Staff Report

Edgewater Redevelopment – 666 Wisconsin Avenue – Mansion Hill Local Historic District Request for Certificate of Appropriateness (including variance(s) if necessary)

Madison Landmarks Commission – May 10, 2010

Legistar ID 15483

Proportions between width and height for street elevations (shown at various scales):

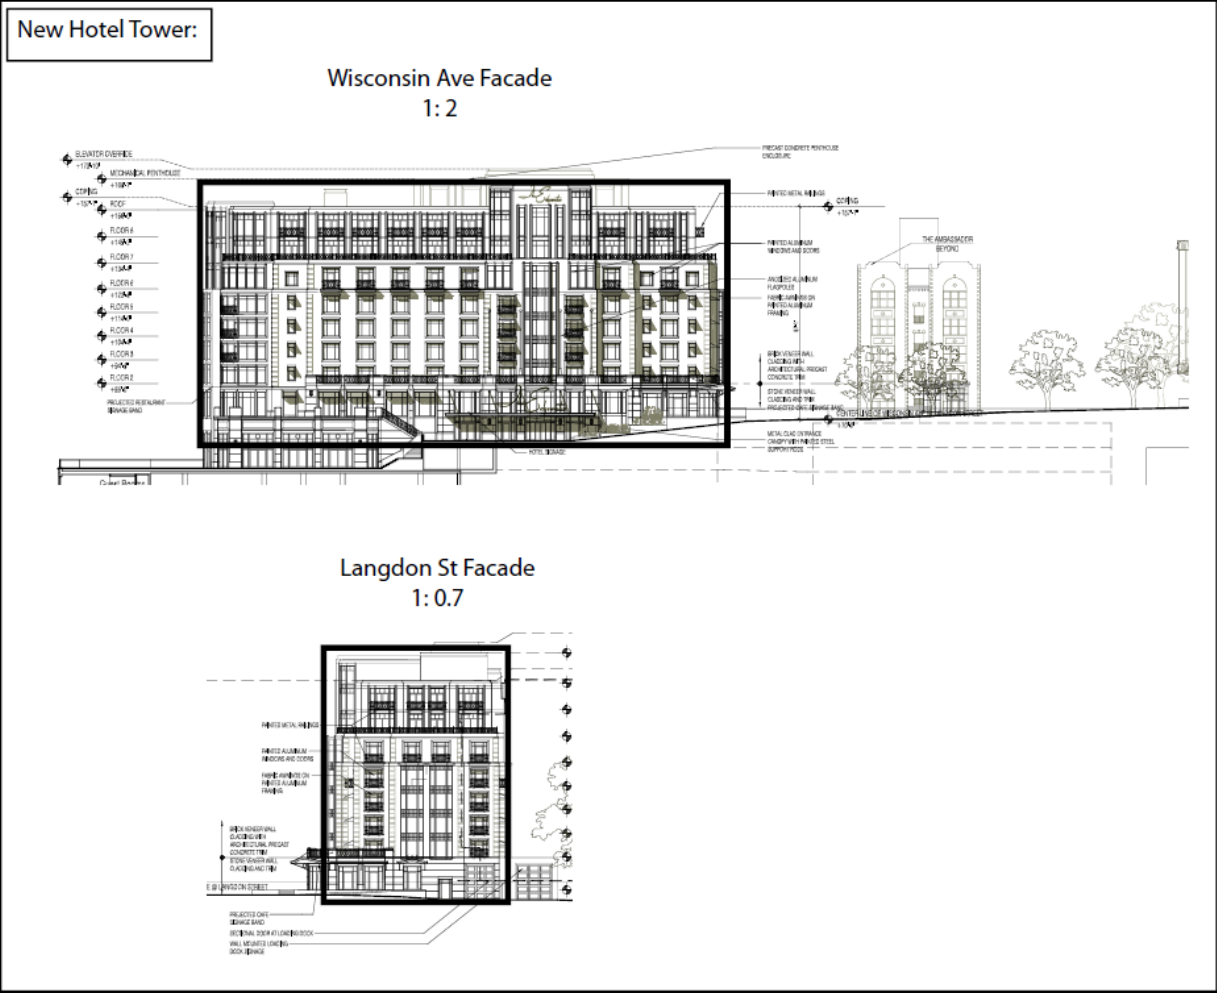
Following is a study that compares these elevations of the proposed new tower to the street elevations of other buildings within the Visually Related Area. While the street elevation(s) are substantially larger than the street elevations of other buildings within the Visually Related Area, this criterion relates to “the proportion between the width and the height in the

facades”, and based on the illustrations below and on the next page, these proportions appear to be similar.
